Request variance from Article 18-4-701 of the Anne Arundel County Code to allow a 10w x 12d x10h ft shed (120 sqft) within 7 ft of the side and rear lot lines of 443 Retford Drive. This shed was built in June of 2022. Due to the property shape and presence of trees, no shed of this dimension would fit within the county code nor in any other location as shown in the following figures. The shed's placement is such to mirror the shed of similar dimensions at 419 Hucknall Court (Lot 11 of Figure 1), equidistant from the property line, approximately 2-3 feet set back. It is also a minimum of 2 feet set back from Lot 10, growing since the property line angles away from the shed. The shed does not have any power nor water connections.

2023-0188-V - site plan revisions needed; sign fee required

MD1312.2013 LOCATION DRAWING LOT 12. BLOCK C CHARTRIDGE, ANNE ARUNDEL COUNTY MARYLAND 12-27-2013 SCALE 1"=30"

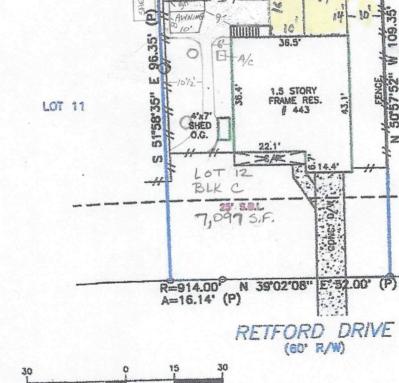
- 1) the dimensions of the shed must be labeled;
- 2) the distance from the shed to both side and rear lot lines must be labeled; and
- 3) please clarify the dimensions and significance of the green-highlighted overhang.

Unfortunately, the site plan is not to scale. Please see the measurement that I've overlaid on the site plan on page 2. Using an image on the site plan that seemed to suggest that the original scale of this plat is/was 1 inch on the page = 30 feet on the ground, I set my scale in Adobe to that figure. You'll see, however, that the distance that's clearly marked on the site plan as a 25 foot setback is measuring at 29.19 feet on this page.

And thanks for the updated site plan, and the explanation of the overhang/awning for the firewood. Unfortunately, the site plan is not quite right yet. The requirements of an administrative site plan to be submitted with a variance application are here, in 18-16-201(e). The two most important aspects for you all, since that previous drawing appears to be mostly complete with your property's outline and improvements, is, first, that the entire property's outline should be shown, with all improvements. And second, ensure that the site plan and the improvements (shed & overhang for firewood) are drawn to scale.

I expect the attached should address your 3 concerns. I tried to upload it to the original submission in the website, but since it's now under review, the ability to add is blocked.

Regarding #3, Figures 2, 3, and 4 in the Letter of Explanation show that I added an awning to the side of the shed to cover our firewood (instead of leaving under tarps as it used to be).
